METROPOLITAN DEVELOPMENT COMMISSION

Case Number: 2025-CPL-825 / 2025-CVR-825 (Amended)

Request: Approval of a Subdivision Plat to be known as Wawa Shortridge Primary Plat, subdividing 9.4 acres into three lots.

Staff Reviewer: Desire Irakoze, Principal Planner II

1Figure 744.701.05 Connector: Frontage Design & Building Placement & Form

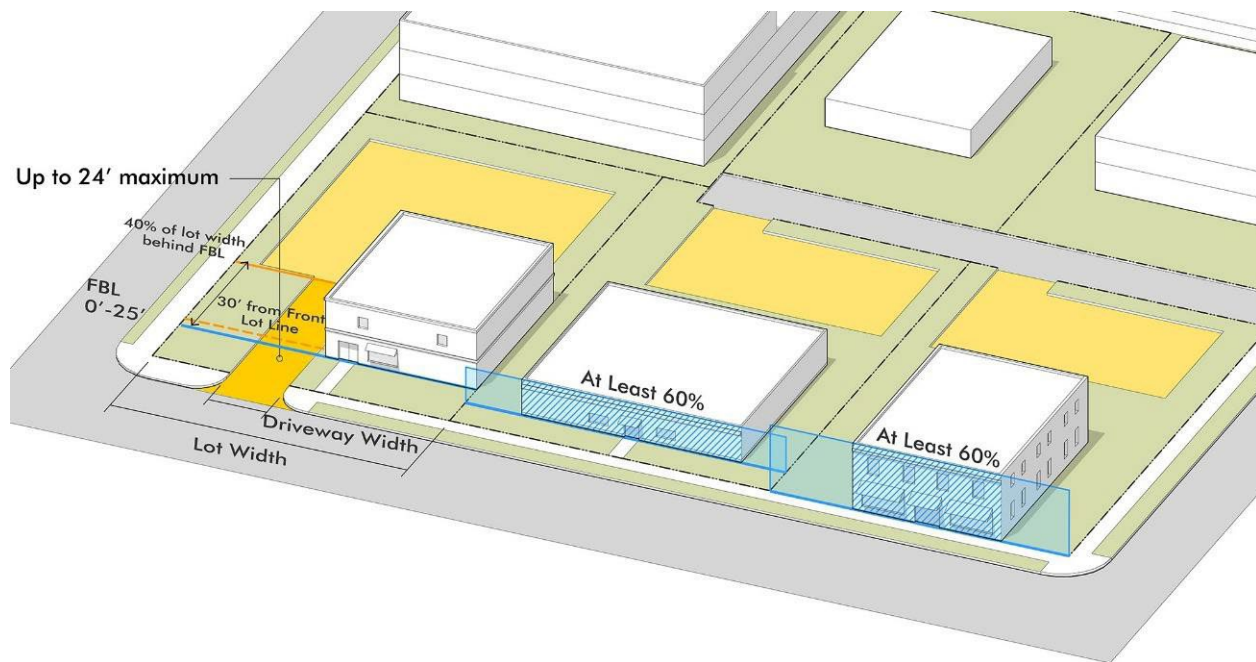
This variance concerns the Commercial Frontage design standards that surface parking behind the front building line may occupy no more than 40% of the entire lot width. The petitioner's site plan shows parking covering 88.1%, more than double the permitted amount.

The petitioner argues for compliance based on 144 lot width along Washington Street, However, the Zoning Ordinance defines the front building line for measuring parking width as: “the actual linear which the front of the building is established, extending across the entire lot.”

Lot B’s entire lot width is 234 feet. The building is 92 feet (39%), where the criteria is 60% and parking no more 40% of the lot width. The petitioner instead proposes the Inverse.

Under Criterion #3, practical difficulty must arise from unique site conditions not of the petitioner’s making. In this case, the difficulty stems solely from a site plan designed in conflict with the Commercial Frontage design standards.

Both are reasonable given the site’s area and configuration. No unique conditions necessitate the excessive parking coverage. The request reflects design preference rather than practical difficulty.

1. Revising the plat to reduce LOT B’s width to match the proposed building footprint; or
2. Increasing the building width to appropriately occupy the lot frontage.

Staff Recommendation: **Denial** of Variance Request #1. Staff encourages revising the plat and/or building footprint to comply with the current Ordinance standards.

2025-CVR-825/ 2025-CPL-825 Updated Elevations

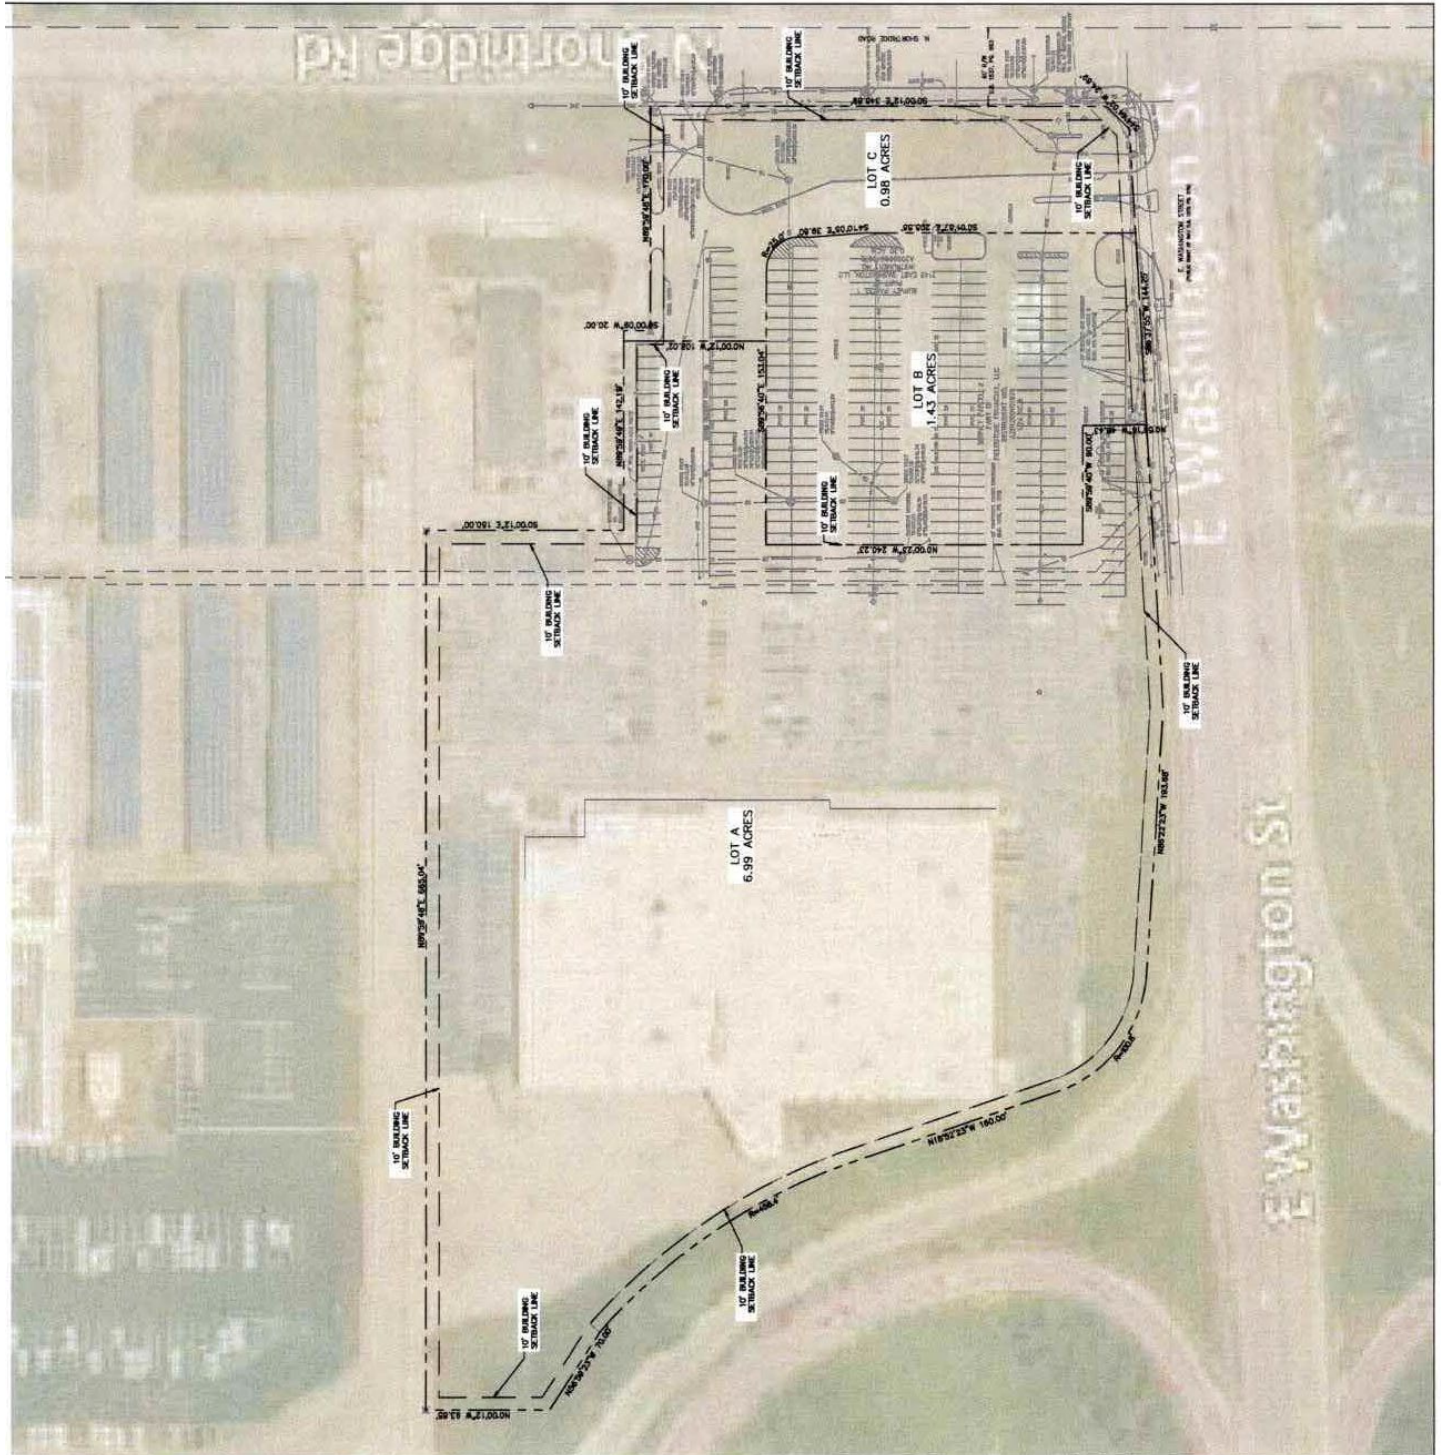
While transparency ratios improved, staff noted that much of the additional glazing is spandrel glass, which is opaque and does not count toward the transparency requirements. Staff recommends a commitment regarding that all glazing materials used meet the definition of transparency as outlined in the Zoning Ordinance.

The submitted building elevations indicate substantial non-compliance. The proposed design provides transparency ratios as low as 0 percent (right elevation) and 8 percent (rear elevation), with the front elevation providing only 25 percent transparent glazing—far below the required minimum. Furthermore, much of the glazing depicted on the elevations is spandrel glass. The petitioner aims to use spandrel glazing has an opaque surface that doesn't let anyone see through the glass, there for neither meeting the criteria nor intent of the transparency.

The petitioner has offered no compelling justification for retaining such a low level of transparency, and staff finds that allowing this variance would directly contradict the TOD Overlay's pedestrian-oriented design objectives. Accordingly, staff **recommends denial** of this variance request and advises the petitioner to revise the building elevations to meet the transparency requirements outlined in both the TOD Overlay and the C-4 district standards.
